Street Extension

Habitat for Humanity

STORMWATER RUNOFF EVALUATION

Demerest Street Extension Portland, Maine

FINAL SUBDIVISION PLAN OF DEMEREST STREET EXTENSION
 FOR HUMANITY OF GREATER PORTLAND/PORTLAND WEST
 565 CONGRESS STREET, PORTLAND, MAINE 04104

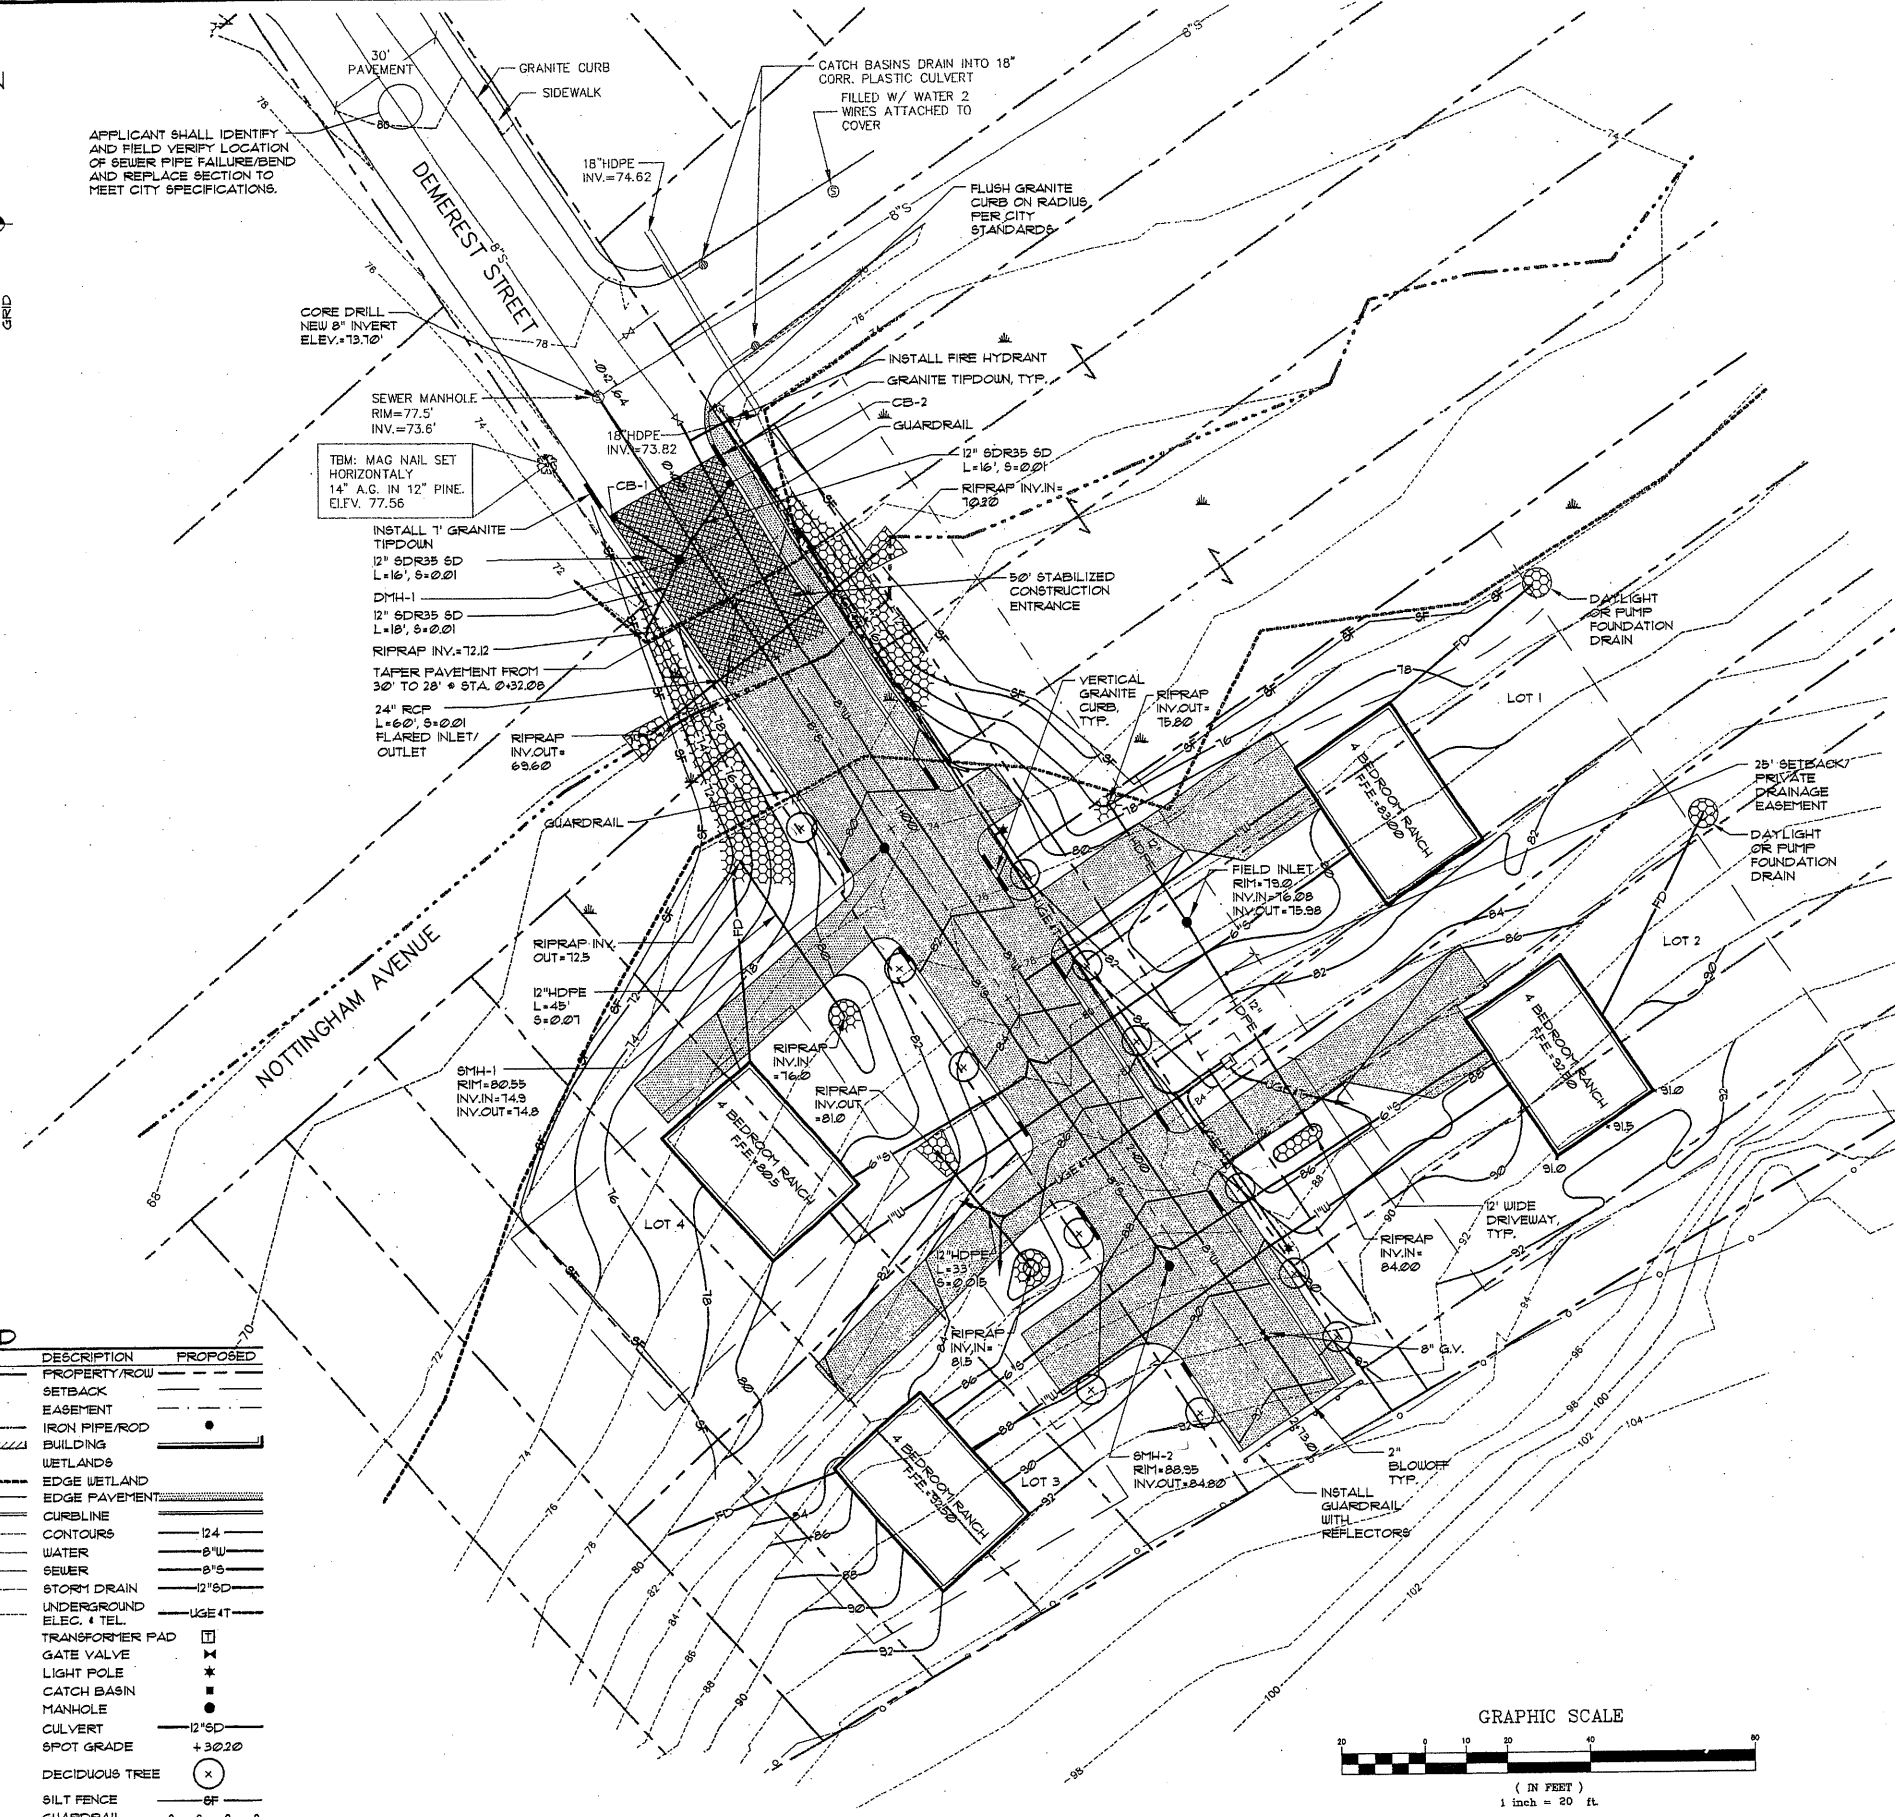
1. The 20' grading easement over the Vance lot will be permanent and will benefit the City of Portland, as shown on the revised plans, for the purposes of side slope grading of the road, and for access and maintenance of the proposed road cross culvert. We have included evidence of the conveyance of the right-of-way property to the City of Portland.
2. The 10' strip in front of Lots 1 and 2 will be part of the right-of-way and will be conveyed to the City. The lot numbers have been added to the revised plans as requested.
3. Note 7 has been revised to indicate that the project will be serviced by public utilities.

GRADING AND UTILITY PLAN
 OF
DEMAREST STREET EXTENSION
 DEMAREST STREET
 PORTLAND, MAINE
 FOR
HABITAT FOR HUMANITY OF GREATER PORTLAND
 565 CONGRESS STREET
 PORTLAND, MAINE 04104

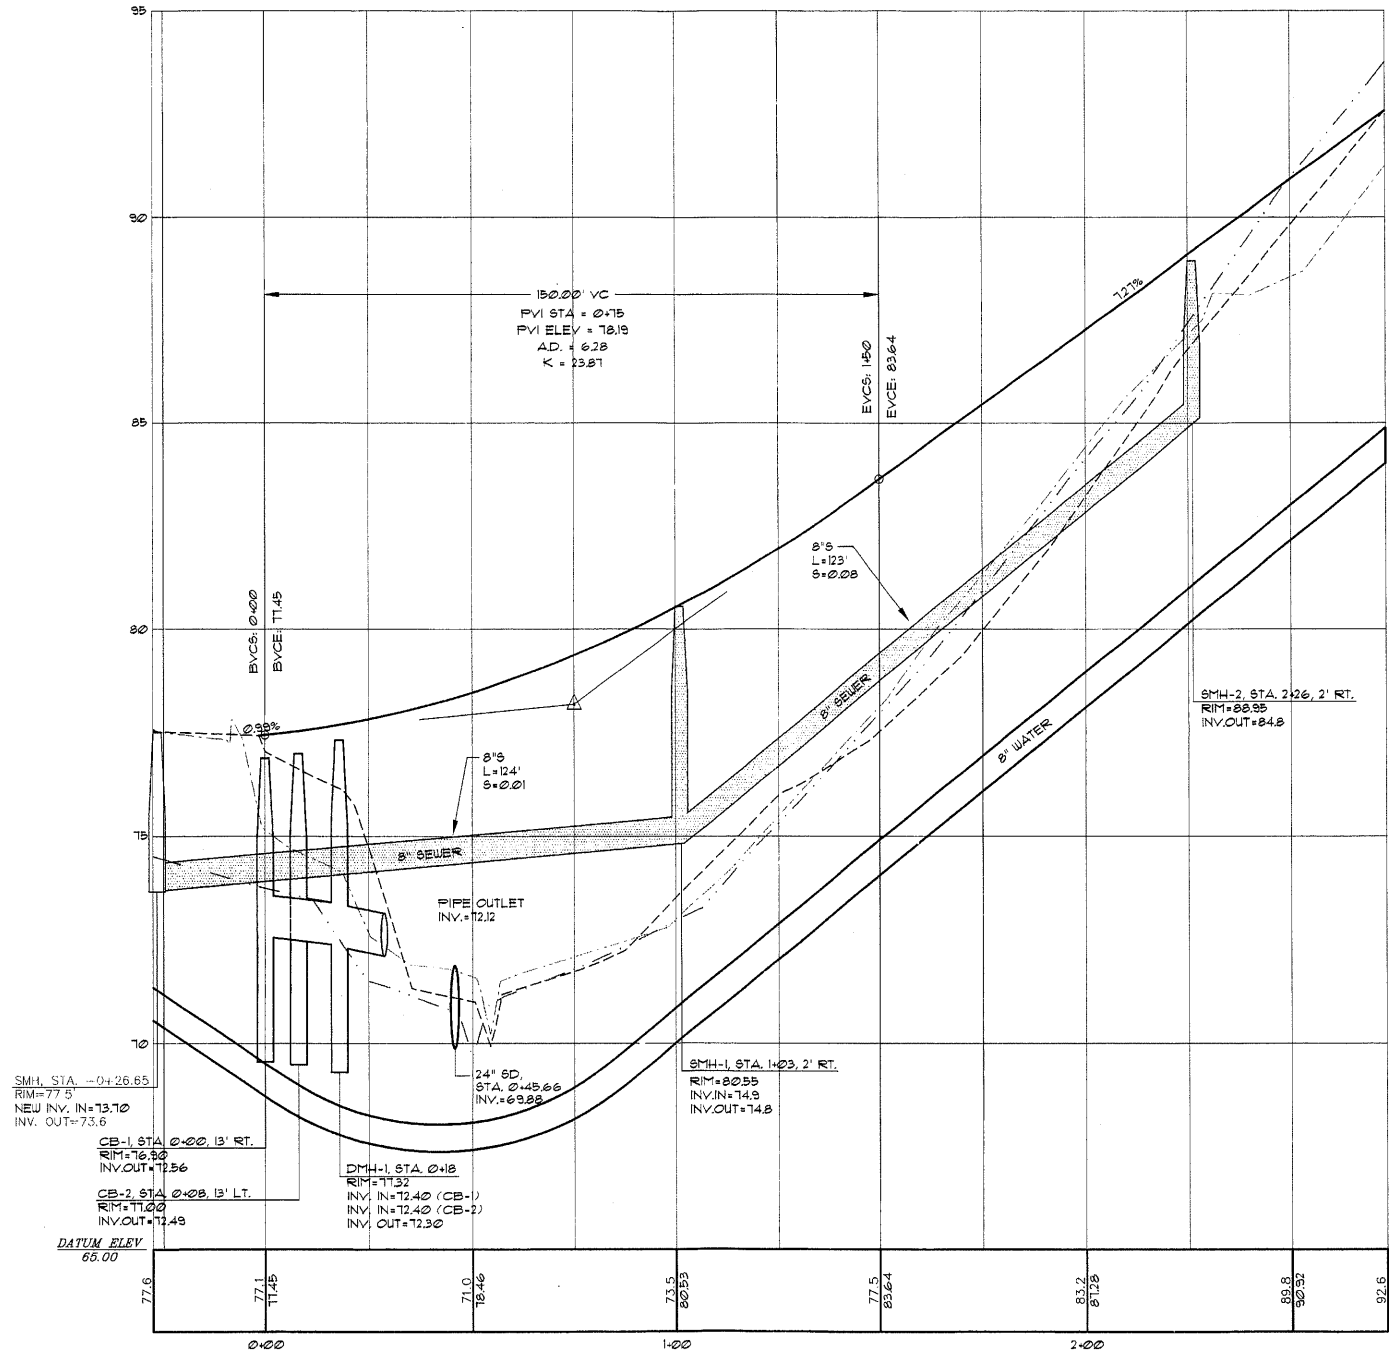
1. The underground electric/telephone/cable lines have been added to the plan, along with the locations of transformers and street lighting.
2. The 24" pipe at the stream crossing has been changed to specify a RCP material. We also revised the plans to specify a flared inlet and outlet on the RCP.

4. Riprap has been added to the slopes at the stream crossing, as requested.
5. The catch basin detail was revised to specify granite curb inlets on Sheet 6 of 6.

6. The grading plan was revised to eliminate the need for drainage easements, which have been removed from the plan.
7. The driveway separation for Lots 3 and 4 was revised to exceed the minimum requirement of 20'.
